Product Change Notification / RMES-19ZBNI141

CCB 4685 Final Notice: Qualification of Ag on lead (Inner Lead Plating) material for selected SST26WF080B and SST26WF040B device families available in 8L UDFN (2x3x0.55mm) package.

Pre and Post Change Summary

PCN #: RMES-19ZBNI141

Lead Frame Comparison

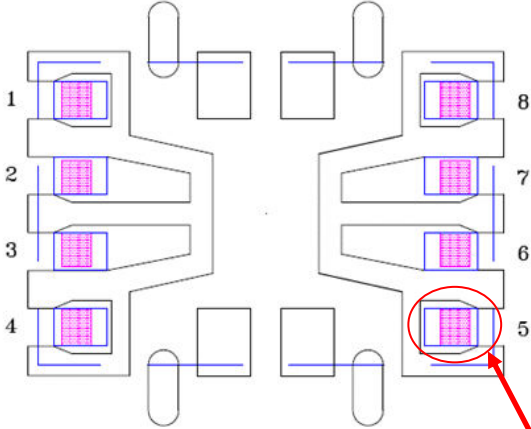
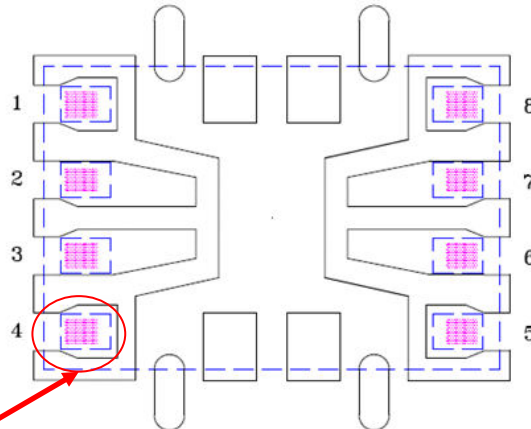
PRE CHANGE	POST CHANGE	REMARKS
LF package/type	8L UDFN 2x3x0.55mm	8L UDFN 2x3x0.55mm	Same
Inner Lead Plating (Bond Finger)	NiPdAu (Pd Custom Plating)	Ag (Ag on lead only)	Different
Lead Finish Plating	Matte Tin	Matte Tin	Same
LF Material	EFTEC-64T	EFTEC-64T	Same
LF Drawing			Different
